NRC 2003-0060

**POINT BEACH NUCLEAR PLANT
DOCKETS 50-266 and 50-301
REQUEST FOR RELIEF FROM THE PROVISIONS OF ASME SECTION XI
IMPRACTICAL REQUIREMENTS**

Attachment
Point Beach Nuclear Plant, Units 1 and 2

Description: Limited Section XI Code examinations during Code required examinations

FIGURE 1

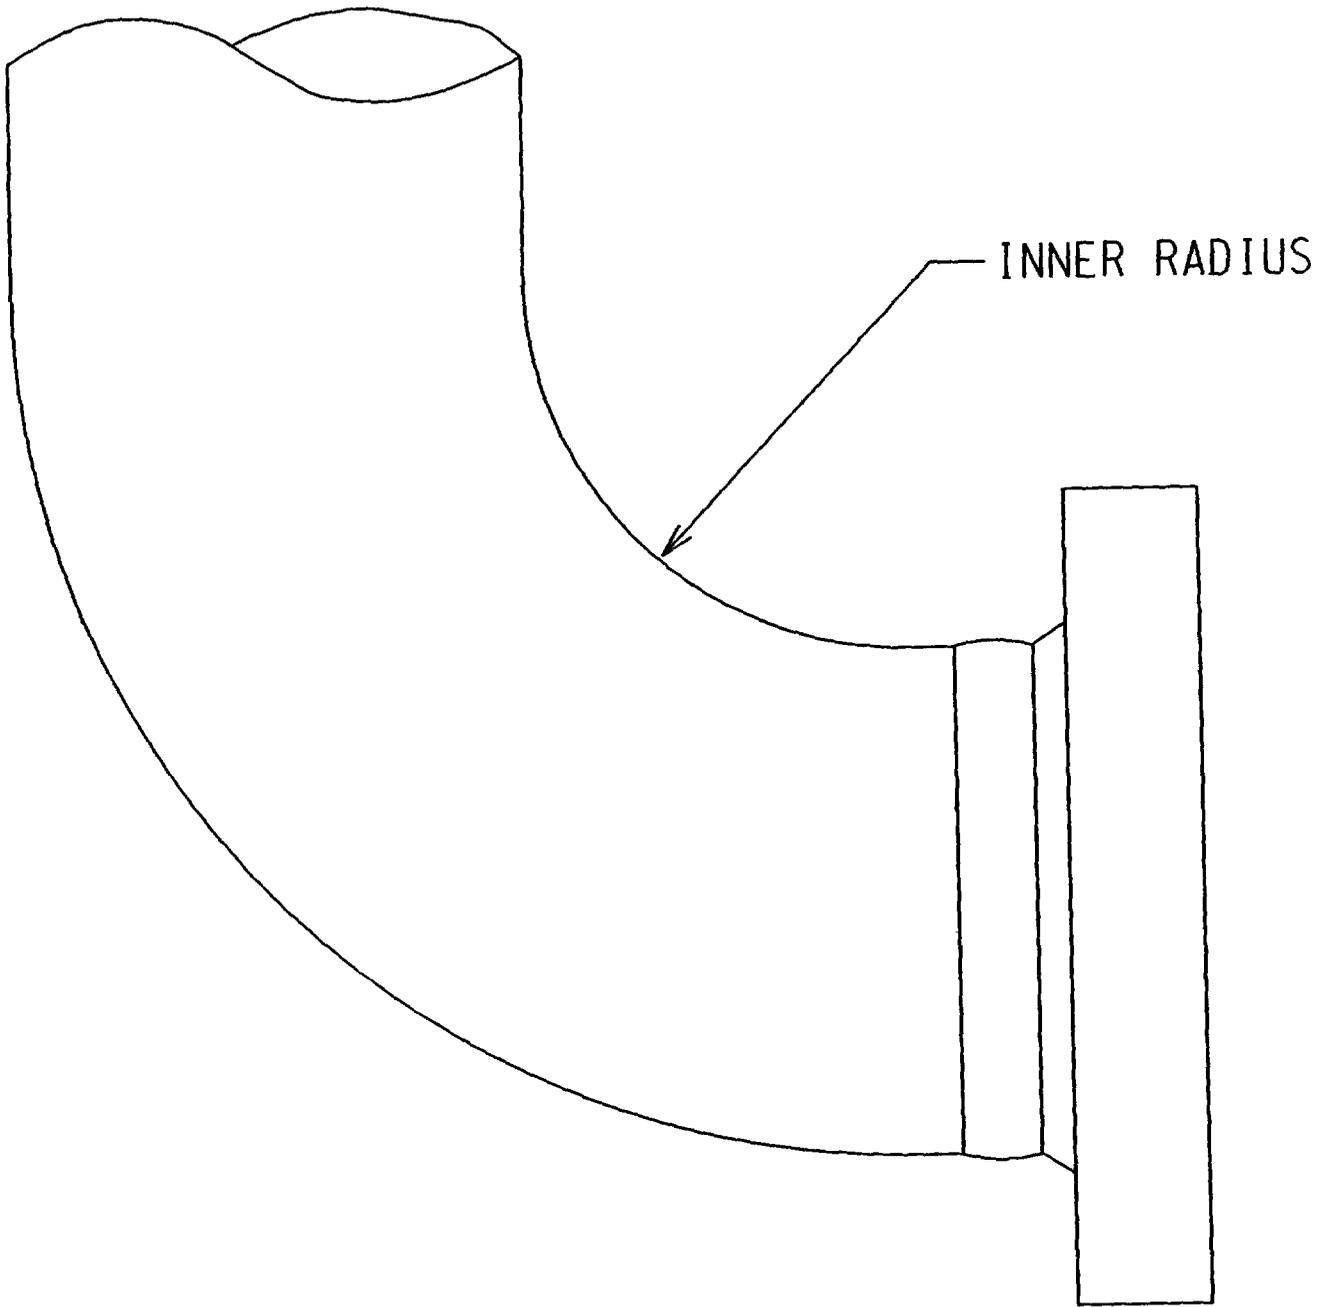
SIS-04-SI-1001-11	C-F-1 C5.11 B	Safety Injection	Elbow to Flange	1	UT	Single side exam from elbow only due to flange configuration. Elbow inner radius prevents complete transducer contact	39%	Note 2
1SI-850A-Welds	C-G C6.20	Safety Injection	Valve Body Welds	See Rmks	PT	Welds partially obstructed due to permanent restraints.	Weld 1 - 51% Weld 2 - 61% Weld 3 - 100% Weld 4 - 100%	Valve has four body welds. Two welds are partially covered by pipe restraints.

FIGURE 2

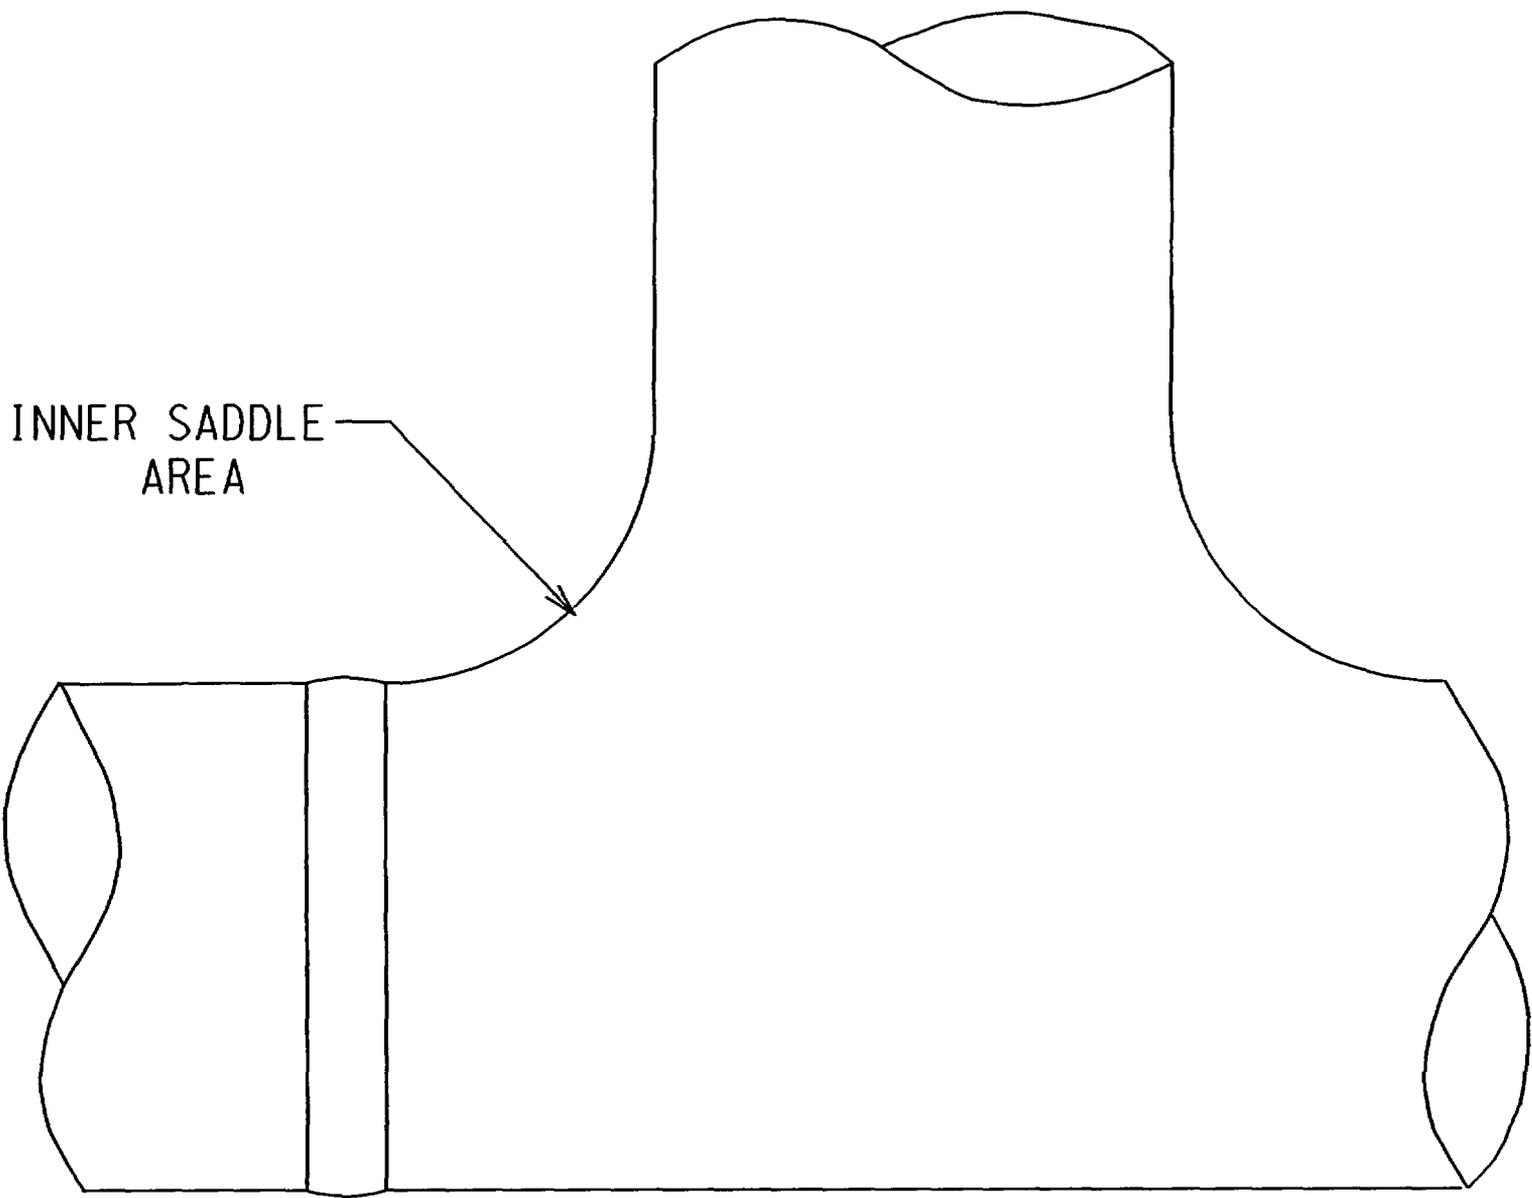
AC-08-RHR-2006-01	C-F-1 C5.11 B	Auxiliary Cooling (RHR)	Tee to Elbow	2	UT	Limited exam due to tee inside saddle configuration preventing complete transducer contact.	73%	Partial coverage was obtained on the remaining 27% of the examination area. see note 1.
AC-08-RHR-2002-04	C-F-1 C5.11 B	Auxiliary Cooling (RHR)	Elbow to Tee	2	UT	Limited exam due to tee inside saddle configuration preventing complete transducer contact	86%	Partial coverage was obtained on the remaining 14% of the examination area. see note 1.
SIS-06-SI-2008-27	C-F-1 C5.11	Safety Injection	Pipe to Valve SI-853B	10	UT	Valve is cast stainless material and is highly attenuative. Limited scan due to pipe restraint and valve configuration	47%	Partial coverage was obtained on the remaining 53% of the examination area.

Figure 5
Elbow to Safe-End/Nozzle to Elbow
(Typical)

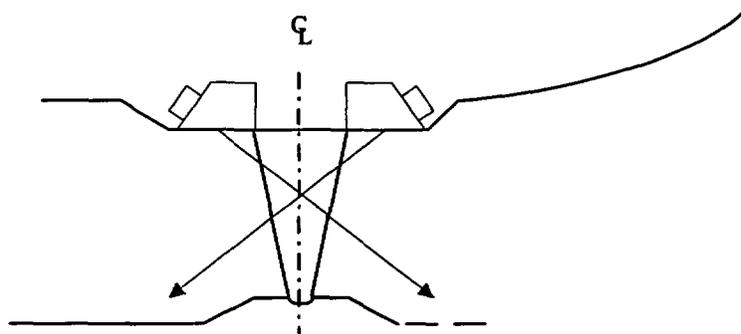
Component Identification	Catgy/ Item no.	System or Component	Configuration	Fig. No.	NDE Method	Limitation Description	Percent Full Coverage	Remarks
RC-34-MRCL-AI-04R1	B-J B9.11	Reactor Coolant	Elbow to S/G Inlet Nozzle Safe-End	5	UT	Elbow is cast material and is highly attenuative, and both elbow and safe-end have a limiting ~1/2" step	40%	Partial coverage was obtained on the remaining 60% of the examination area.
RC-36-MRCL-AII-01R1	B-J B9.11	Reactor Coolant	S/G Outlet Nozzle Safe- End to Elbow	5	UT	Elbow is cast material and is highly attenuative, and both elbow and safe-end have a limiting ~1/2" step	36%	Partial coverage was obtained on the remaining 64% of the examination area.
RC-36-MRCL-AII-03	B-J B9.11	Reactor Coolant	Pipe to Elbow	8	UT	Elbow is cast material and is highly attenuative, and has limiting ~1/8" step	83%	Partial coverage was obtained on the remaining 17% of the examination area.

RC-34-MRCL-BI-04R1	B-J B9.11	Reactor Coolant	Elbow to S/G Inlet Nozzle to Safe End	5	UT	Elbow is cast material and is highly attenuative, and both nozzle and safe-end have a limiting ~1/2" step.	17%	Partial coverage was obtained on the remaining 83% of the examination area.
RC-36-MRCL-BII-01R1	B-J B9.11	Reactor Coolant	S/G Outlet Nozzle Safe End to Elbow	5	UT	Elbow is cast material and is highly attenuative, and both elbow and safe-end have a limiting ~1/2" step.	30%	Partial coverage was obtained on the remaining 70% of the examination area.
RC-36-MRCL-BII-04	B-J B9.11	Reactor Coolant	Elbow to Pipe	8	UT	Elbow is cast material and is highly attenuative, and has a limiting ~1/2" step. Weld configuration prevents proper transducer contact.	25%	Partial coverage was obtained on an additional 24% of the examination area.
RC-10-AC-2001-01	B-J B9.11	Reactor Coolant	Branch Connection to Elbow	14	UT	Limited exam due to branch connection configuration	54%	Partial coverage was obtained on the remaining 46% of the examination area.

Figure 6
Safe-End to Nozzle
(Typical)

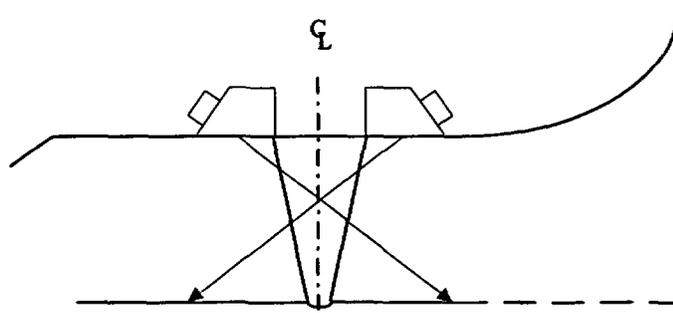
RC-34-MRCL-AI-05	B-F B5.70	Reactor Coolant	Safe-End to A S/G Inlet Nozzle	6	UT	Scan limited by safe-end and nozzle geometries	59%	Nozzle blend radius prevents proper transducer contact
RC-34-MRCL-BI-05	B-F B5.70	Reactor Coolant	Safe-End to B S/G Inlet Nozzle	6	UT	Scan limited by safe-end and nozzle geometries	59%	Nozzle blend radius prevents proper transducer contact
RPV Closure Nut	B-G-1 B6.10	Reactor Pressure Vessel	Closure Nut	12	MT	Middle 1/3 of threaded area inside of nut is inaccessible	67%	Geometric limitation of nut

Figure 7
 Elbow to Nozzle/Nozzle to Elbow
 Reactor Coolant Main Loop
 (Typical)

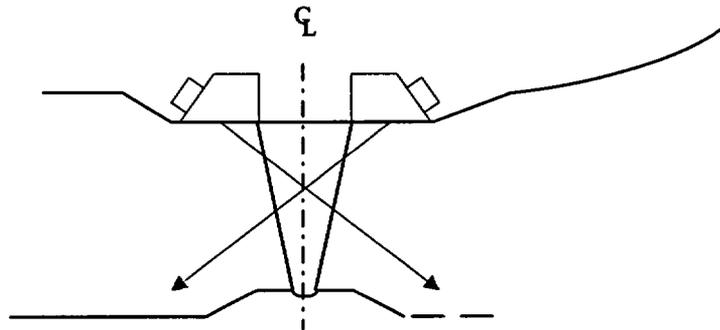
RC-36-MRCL-AII-01	B-F B5.130	Reactor Coolant	S/G Outlet Nozzle to Elbow	7	UT	Elbow is static cast stainless steel and is highly attenuative, and has limiting ~1/2" step. Nozzle blend radius limits proper transducer contact	2%	An additional 29% partial coverage was obtained
RC-34-MRCL-BI-03	B-F B5.130	Reactor Coolant	Elbow to S/G Inlet Nozzle	7	UT	Elbow is static cast stainless steel and is highly attenuative, and has limiting ~1/2" step. Nozzle blend radius limits proper transducer contact.	31%	An additional 31% partial coverage was obtained

Point Beach Nuclear Plant Unit 1								
Component Identification	Catgy/ Item no.	System or Component	Configuration	Fig. No.	NDE Method	Limitation Description	Percent Full Coverage	Remarks
RC-36-MRCL-BII-01	B-F B5.130	Reactor Coolant	S/G Outlet Nozzle to Elbow	7	UT	Elbow is static cast stainless steel and is highly attenuative, and has limiting ~1/2" step. Nozzle blend radius limits proper transducer contact.	14%	An additional 36% partial coverage was obtained
RPV Closure Nut	B-G-1 B6.10	Reactor Pressure Vessel	Closure Nut	12	MT	Middle 1/3 of threaded area inside of nut is inaccessible	67%	Geometric limitation of nut in the threaded area
RC-34-MRCL-BI-02	B-J B9.11	Reactor Coolant	Pipe to Elbow	8	UT	Elbow is static cast stainless steel and is highly attenuative. Elbow has limiting ~1/2" step. Weld has limiting ~1/2" step.	74%	
RC-36-MRCL-BII-02	B-J B9.11	Reactor Coolant	Elbow to Pipe	8	UT	Elbow is static cast stainless steel and is highly attenuative. Elbow has limiting ~1/2" step.	79%	An additional 21% partial coverage was obtained on the remainder of the examination area.

RC-36-MRCL-BII-06	B-J B9.11	Reactor Coolant	Elbow to Pump	7	UT	Elbow is static cast stainless steel and is highly attenuative. Elbow has limiting ~1/2" step. Pump configuration does not allow any examination.	0%	An additional 59% partial coverage was obtained from the elbow side. The nozzle on Fig. 7 is similar to the configuration of the RC pump but with less area from which to examine.
RC-08-DR-1001-01	B-J B9.11	Reactor Coolant	Branch Connection to Pipe	14	UT	Limited exam due to branch connection configuration	46%	An additional 54% partial coverage was obtained on the remainder of the examination area.

Figure 10
Pipe to Valve/Valve to Pipe
(Typical)

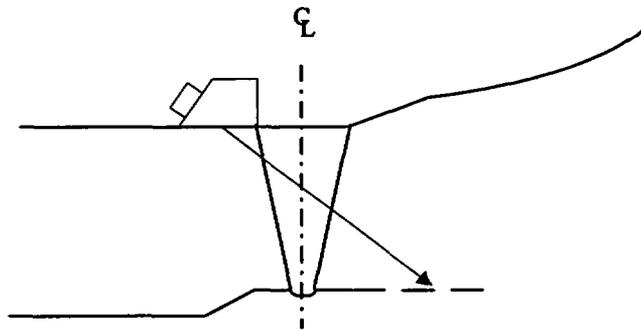
Point Beach Nuclear Plant Unit 1								
Component Identification	Catgy/Item no.	System or Component	Configuration	Fig. No.	NDE Method	Limitation Description	Percent Full Coverage	Remarks
SIS-10-SI-1003-19	B-J B9.11	Safety Injection	Elbow to Valve 1SI-867A	10	UT	Valve is cast stainless material and is highly attenuative. Limited exam due to valve configuration	9%	An additional 41% partial coverage was obtained on the remainder of the examination area. Best effort examination on 50% of examination area (valve side) see note 1.
RC-10-SI-1003-20	B-J B9.11	Reactor Coolant	Valve 1SI-867A to Elbow	10	UT	Valve is cast stainless material and is highly attenuative. Limited exam due to valve configuration	28%	An additional 27% partial coverage was obtained on the remainder of the examination area. Best effort examination on 50% of examination area (valve side) see note 1.
RC-10-SI-1003-21	B-J B9.11	Reactor Coolant	Elbow to Branch Connection	14	UT	Limited exam due to branch connection configuration	33%	An additional 18% partial coverage was obtained on the remainder of the examination area. Best effort examination on 50% of examination area (pipe side) see note 1.

AC-10-SI-1001-19	B-J B9.11	Auxiliary Cooling (SI)	Pipe to Valve 1SI-867B	10	UT	Valve is cast stainless material and is highly attenuative. Limited exam due to valve configuration	14%	An additional 36% partial coverage was obtained on the remainder of the examination area. Best effort examination on 50% of examination area (valve side) see note 1.

Component Identification	Catgy/Item no.	System or Component	Configuration	Fig. No.	NDE Method	Limitation Description	Percent Full Coverage	Remarks
RC-10-AC-2001-11	B-J B9.11	Reactor Coolant	Pipe to Valve 2RH-700	10	UT	Valve is cast stainless material and is highly attenuative. Limited exam due to valve configuration and welded attachment.	77%	Support is welded to the 10" pipe and restricts 4-1/2" of weld length.
RC-06-SI-2002-26	B-J B9.11	Reactor Coolant	Elbow to Pipe	1	UT	Limited scan due to welded attachment, elbow inner radius prevents complete transducer contact.	85%	Support is welded to the 6" pipe and restricts 3-1/2" of weld length. Partial coverage was obtained on the remaining 15% of the examination area.
AC-10-RHR-2004-09	C-F-1 C5.11 B	Auxiliary Cooling (RHR)	Pipe to Tee	2	UT	Limited exam due to tee inside saddle configuration preventing complete transducer contact.	90%	Partial coverage was obtained on the remaining 10% of the examination area. see note 1.

Figure 15
Reactor Pressure Vessel
Head to Flange Weld
(Typical)

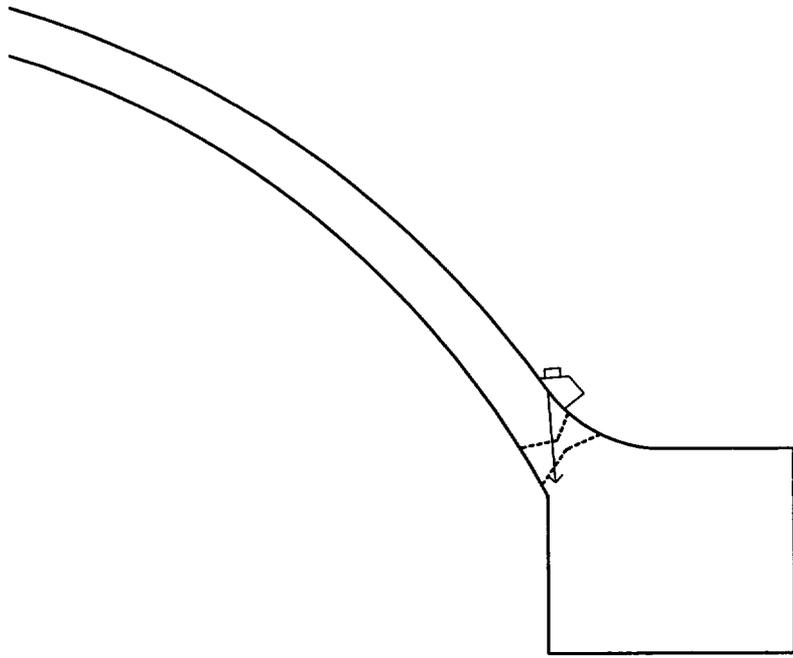
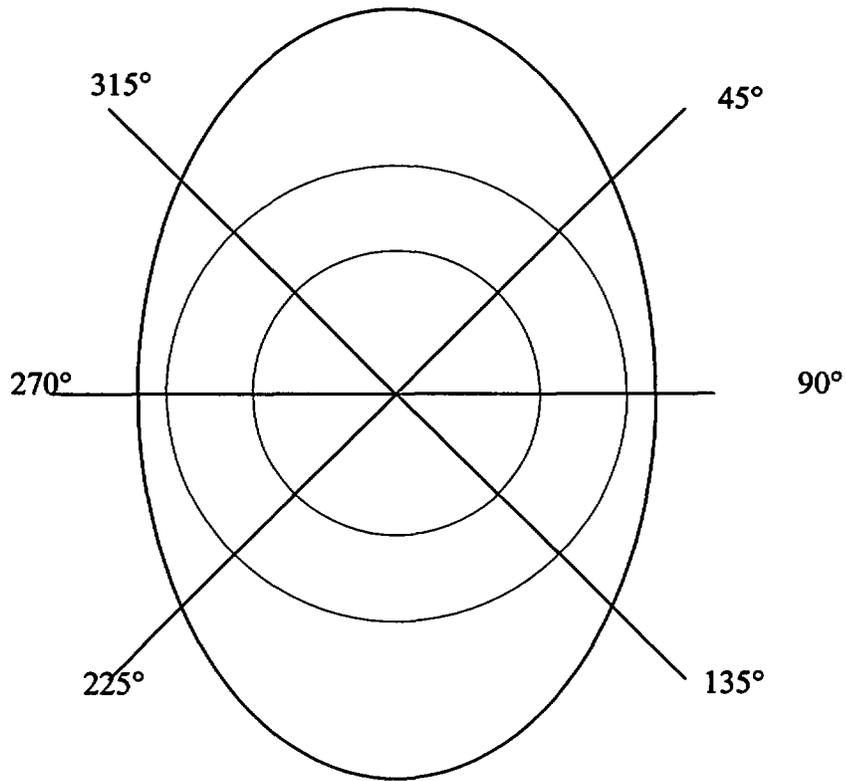
Point Beach Nuclear Plant Unit 1								
Component Identification	Catgy/Item no.	System or Component	Configuration	Fig. No.	NDE Method	Limitation Description	Percent Full Coverage	Remarks
RPV-HFlange	B-A B1.40	Reactor Pressure Vessel	Head to Flange	15	UT	Limited by welded attachments of head lift rig and flange configuration	86%	100% Exam From Head Side, Partial exam from flange side
PZR-SprayNoz-IRS	B-D B3.120	Pressurizer Inside Radius Section	Inside Radius Section	11	UT	Examination limited due to nozzle configuration and permanent insulation support rings	73%	
RHE-N1-IRS	B-D B3.150	Regenerative Heat Exchanger	Inlet Nozzle Inner Radius	16	UT	Exam limited due to nozzle configuration.	~50%	
RHE-N4-IRS	B-D B3.150	Regenerative Heat Exchanger	Outlet Nozzle Inner Radius	16	UT	Exam limited due to nozzle configuration.	~50%	
RC-34-MRCL-AI-03	B-F B5.130	Reactor Coolant	Elbow to S/G Inlet Nozzle	7	UT	Elbow is static cast stainless steel and is highly attenuative, and has limiting ~1/2" step. Nozzle blend radius limits proper transducer contact	31%	An additional 31% partial coverage was obtained

Point Beach Nuclear Plant Unit 2								
Component Identification	Catgy/Item no.	System or Component	Configuration	Fig. No.	NDE Method	Limitation Description	Percent Full Coverage	Remarks
RPV-HFlange	B-A B1.40	Reactor Pressure Vessel	Head to Flange	15	UT	Limited by welded attachments of head lift rig and flange configuration	87%	100% Exam From Head Side, Partial exam from flange side
PZR-SprayNoz-IRS	B-D B3.12 0	Pressurizer	Inside Radius Section	11	UT	Examination limited due to nozzle configuration and permanent insulation support rings	88%	
RHE-N1-IRS	B-D B3.15 0	Regenerative Heat Exchanger	Inlet Nozzle Inner Radius	16	UT	Exam limited due to nozzle configuration.	~50%	
RHE-N4-IRS	B-D B3.15 0	Regenerative Heat Exchanger	Outlet Nozzle Inner Radius	16	UT	Exam limited due to nozzle configuration.	~50%	
PZR-SurgeNoz-SE	B-F B5.40	Pressurizer	Safe-End to Nozzle	6	UT	Single side exam due to nozzle configuration	0%	100% partial coverage was obtained from the safe-end side Nozzle blend radius prevents proper transducer contact

**End View
(Typical)
Figure 16**

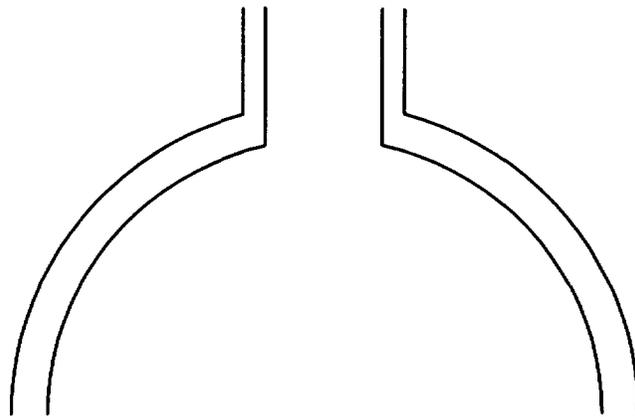
Examination Limited from 45 to 135 and from 225 to 315 due to nozzle configuration. 50% of total area examined, 100% of accessible area examined.

Figure 17
Welded Support Limitations
(Typical)

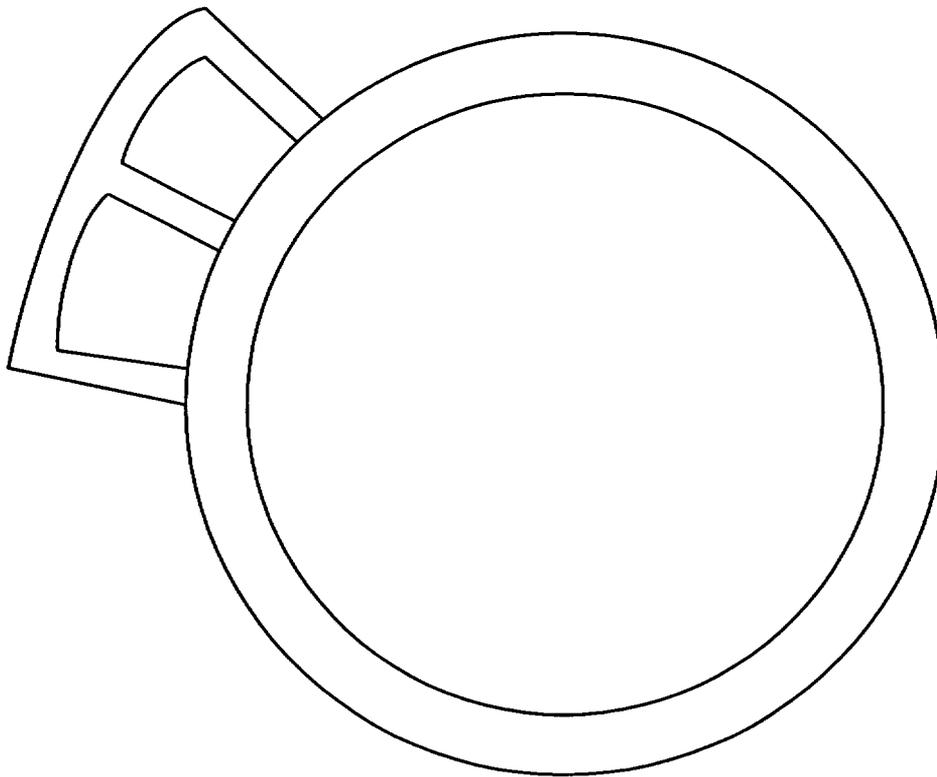
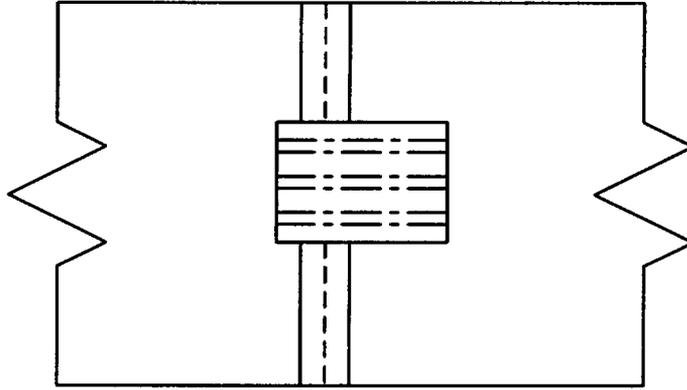
Point Beach Nuclear Plant Unit 1								
Component Identification	Catgy/Item no.	System or Component	Configuration	Fig. No.	NDE Method	Limitation Description	Percent Full Coverage	Remarks
RC-10-SI-1001-21	B-J B9.11	Reactor Coolant	Elbow to Pipe	17	UT	Limited by three welded attachments.	89%	Best effort examination on 4% of examination area (pipe side) Welded attachments are 1" wide and cover the weld and pipe side. see note 1.
AC-06-SI-1001-21	B-J B9.11	Auxiliary Cooling (SI)	Pipe to Valve 1SI-853D	10	UT	Valve is cast stainless material and is highly attenuative. Single side exam due to valve configuration	50%	Best effort examination on 50% of examination area (valve side) see note 1.
AC-08-RHR-1006-02	C-F-1 C5.11 B	Auxiliary Cooling (RHR)	Elbow to Valve 1RH-718B	10	UT	Valve is cast stainless material and is highly attenuative. Single side exam due to valve configuration	36%	An additional 35% partial coverage was obtained on the remainder of the examination area. Note 2
